Office Action Summary

10/714,848

MAEKAWA ET AL.

FIG. 2
PRIOR ART

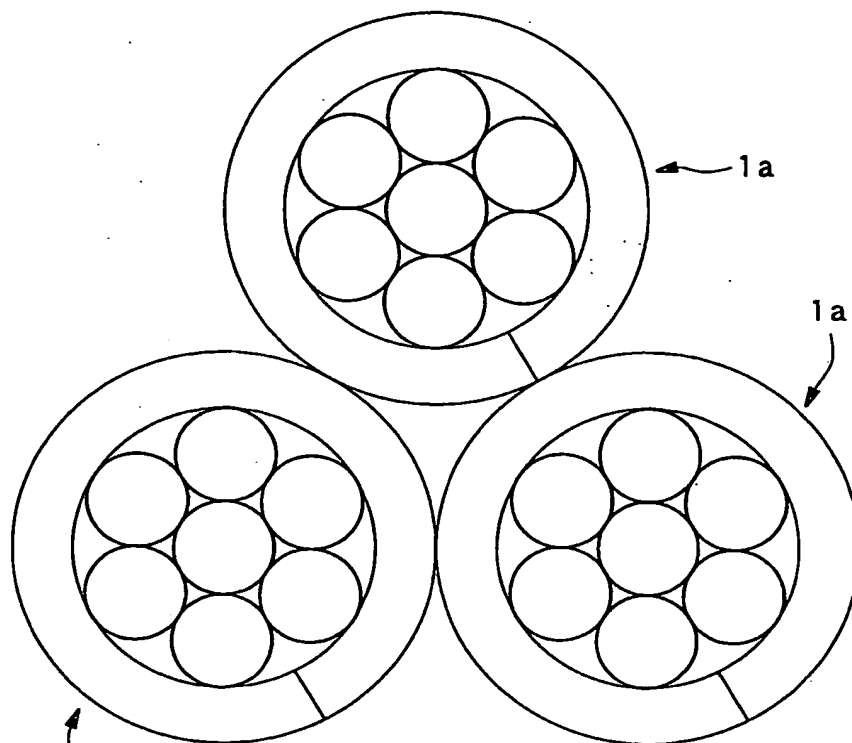
Applicant argues that the plurality of strands (10) of Taylor et al. are insulated wires, while the core threads (21) of the present invention are not insulated within each wire. Applicant has confused between strands, core threads, conductors and wires. Figure 3 of AAPA discloses each wire (1b) comprising three conductors (1a, see Figure 2 of AAPA), each conductor (1a) comprising core threads (11) which are **uninsulated** core threads and which are wrapped around by conductive element (12, see Figure 1A of AAPA). Accordingly, Figures 1-3 of AAPA discloses the invention substantially as claimed including each conductor comprising core threads which are uninsulated core threads. Figures 1-3 of AAPA does not disclose the conductors (1a) being insulated from each other. Taylor et al. teaches each wire (B, Figure 1 corresponding to each wire 1b of Figure 3 of AAPA)

comprising conductors (10) which are insulated from each other by insulating (12). Taylor et al. is relied upon for the teaching of insulating conductors from each other in a bundle to improve the signal transmission and to protect the conductors. The feature of each conductor comprising a plurality of uninsulated core threads is disclosed in Figures 1-3 of AAPA.

1a = Wire 10 of Taylor
1b = bundle B of Taylor
